Model: ME-P1	Date: 20-Oct-11	No.: RM101001d
--------------	-----------------	----------------

Subject: Firmware Release Note: Controller for China models		Prepared by: Y. Miyamoto	
From: 1st Tech Service Sect., MFP/Printer Tech Service Dept.			
Classification:	<input type="checkbox"/> Troubleshooting <input type="checkbox"/> Mechanical <input type="checkbox"/> Paper path <input type="checkbox"/> Product Safety	<input type="checkbox"/> Part information <input type="checkbox"/> Electrical <input type="checkbox"/> Transmit/receive <input checked="" type="checkbox"/> Other (Firmware)	<input type="checkbox"/> Action required <input type="checkbox"/> Service manual revision <input type="checkbox"/> Retrofit information <input checked="" type="checkbox"/> Tier 2

Model: ME-P1/MF1		Date: 20-Dec-11	No.: RM101005
Subject: Service manual correction		Prepared by: Y. Murata	
From: 3rd Tech Service Sect., MFP/P Tech Service Dept.			
Classification:	<input type="checkbox"/> Troubleshooting <input type="checkbox"/> Part information <input type="checkbox"/> Action required <input type="checkbox"/> Mechanical <input type="checkbox"/> Electrical <input checked="" type="checkbox"/> Service manual rev

p. 202

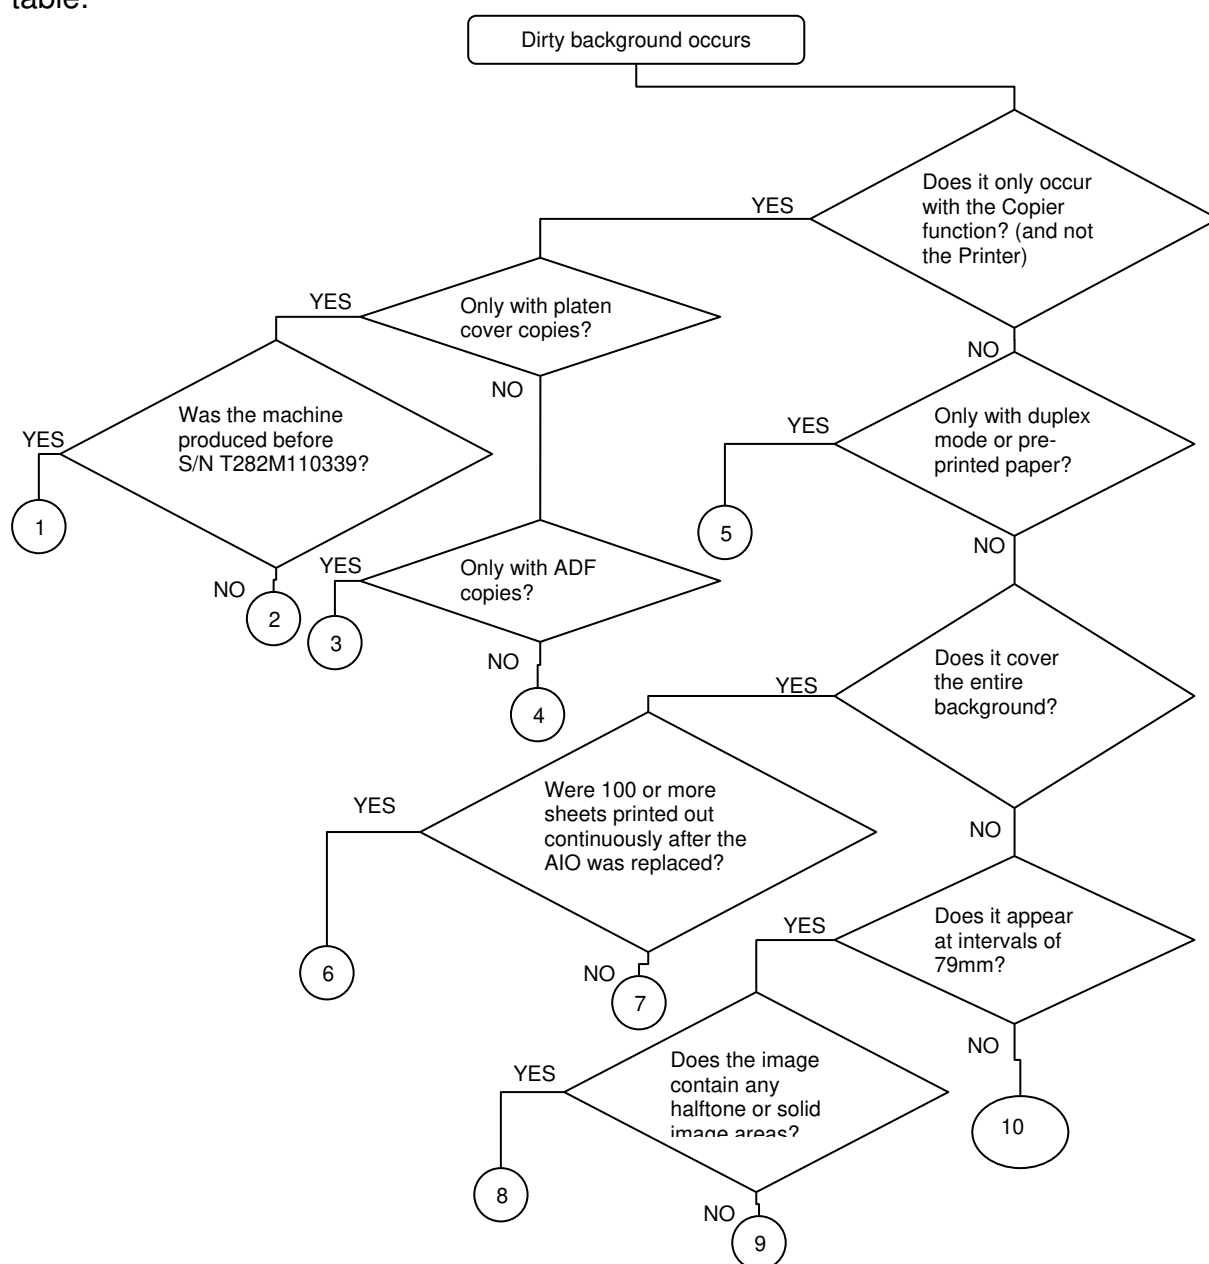
C6 => c6 (C was a small letter)

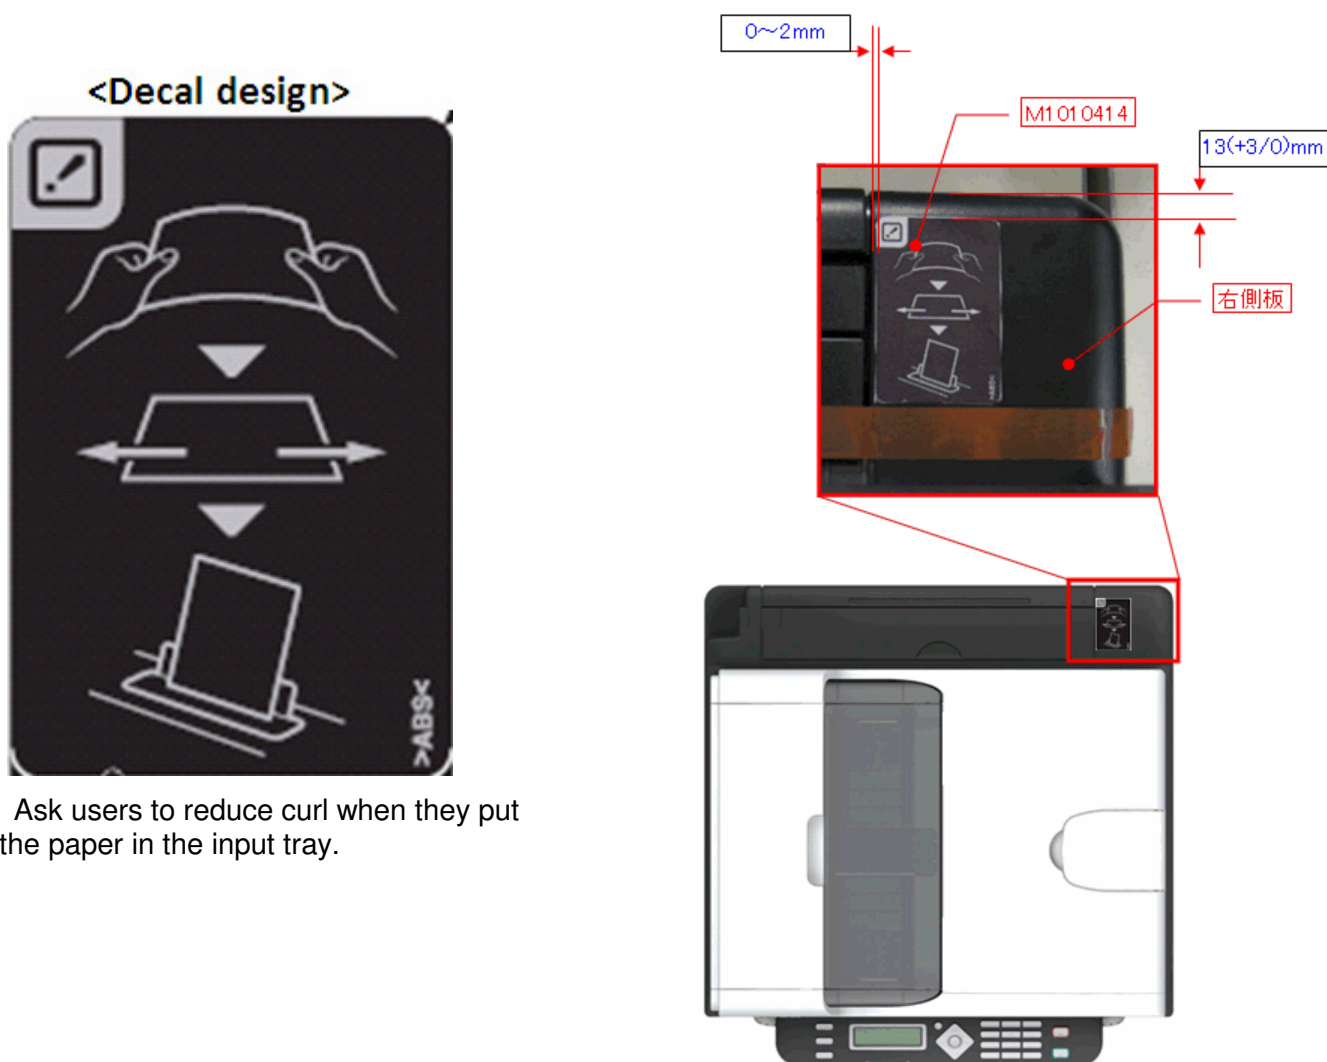
The paper guide decal is now available as a service part to reduce creasing and misfeeds. Please paste it in the following place when needed.

P/N	Description	Q'ty
M1010414	DECAL:PAPER GUIDE	1

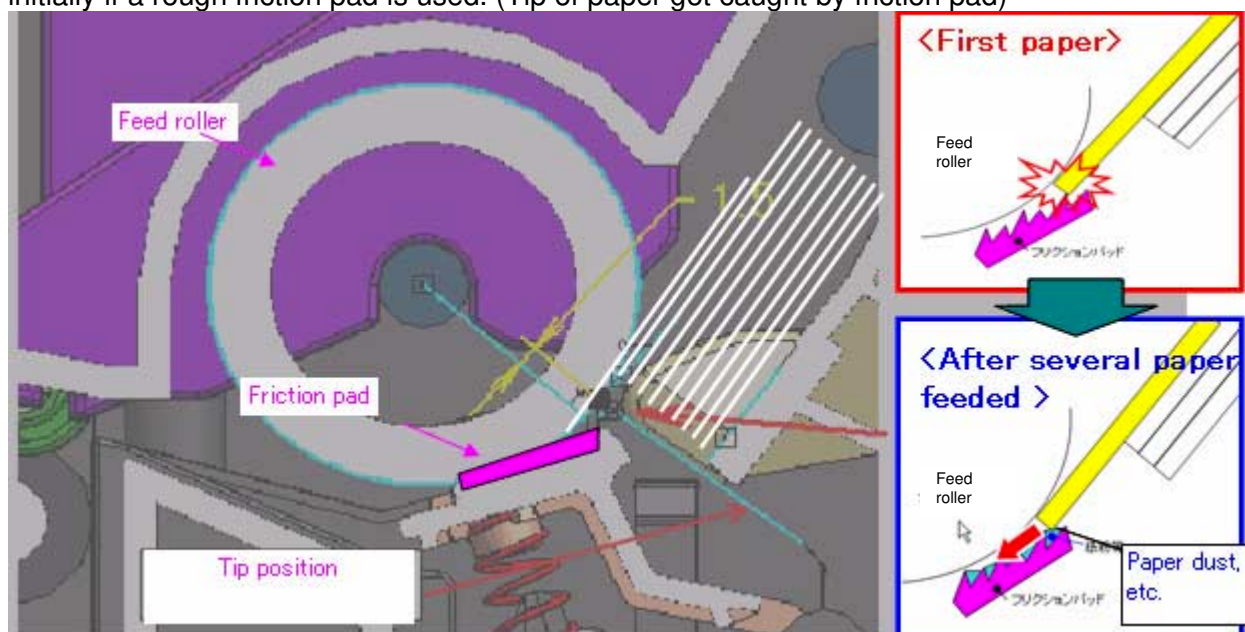
There is variation in roughness of the friction pad surface and some machines show high jam ratio initially if a rough friction pad is used. (Tip of paper got caught by friction pad)

**Permanent countermeasure will be applied from July production. The material of the pad will be changed.

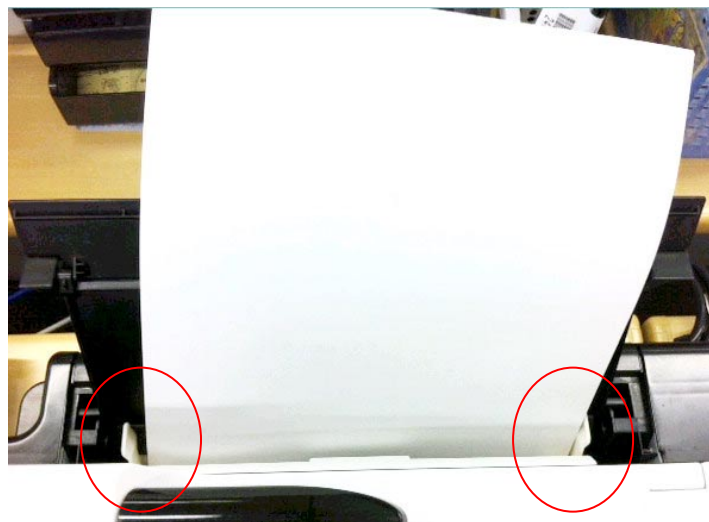
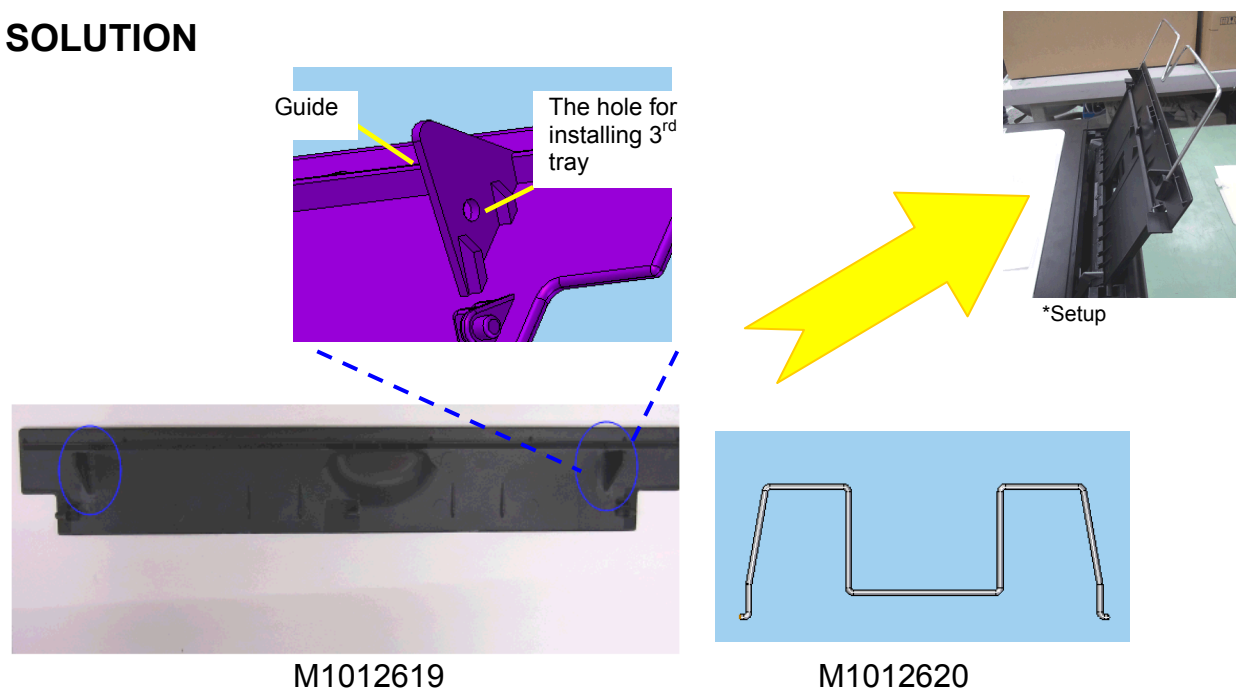
1. A paper jam or paper wrinkling may occur if curled paper is loaded in the paper tray.

2. A paper feed jam may occur if the side fence is not locked tightly in place.

1. Extension tray: Two guides were added, to minimize paper skew.
2. A third extension tray was added to minimize paper curl.

Procedure

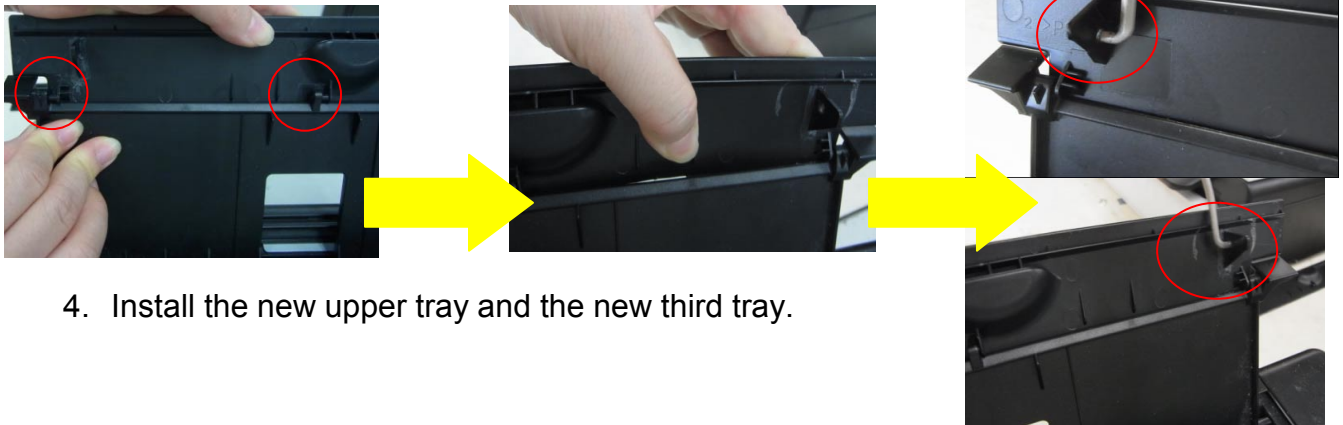
1. Pull the tray fully out, and carefully bend the upper tray.
2. Release the axle on the right side.
3. Slide the whole upper tray to the right and remove it.

4. Install the new upper tray and the new third tray.
